T-Power NV

Brussels, 22 December 2021

Formal public consultation of the stakeholders on the Functioning Rules of the Belgian Capacity Remuneration Mechanism ("CRM") in accordance with Art. 7 undecies §12 of the Electricity Act.

- **3.** In the Introduction, in point 3., we believe reference will also have to be made to the relevant Royal Decrees that will have to be concluded in the course of 2022.
- **4.** §4.3.5

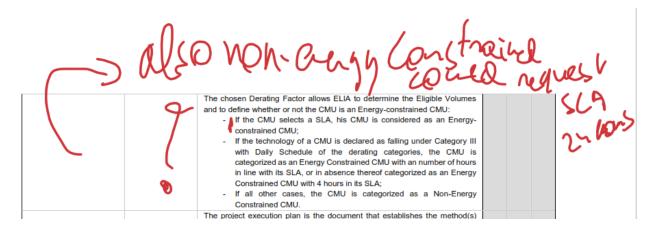
Could it be that there is an error in the cell mentioning D+5 working days... Would think this should be D+4 based on the text next to it, because the notification is done at D-1.

17. §17.1 Typo

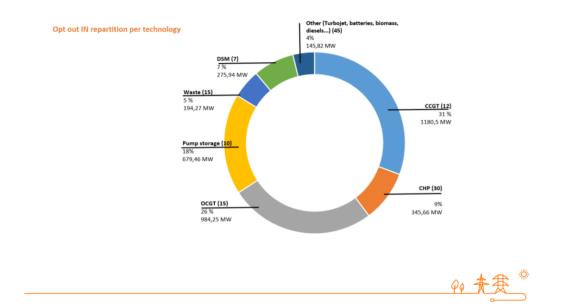
The Royal Decree on the on the eligibility conditions for indirect foreign capacity defines the principles, conditions and modalities applicable to the Eligible Direct Foreign Capacity Holder and Eligible Indirect Foreign Capacity Holder for their participation in the Belgian CRM Prequalification Process and refers for several aspects to the CRM Functioning Rules for the exact details on the modalities.
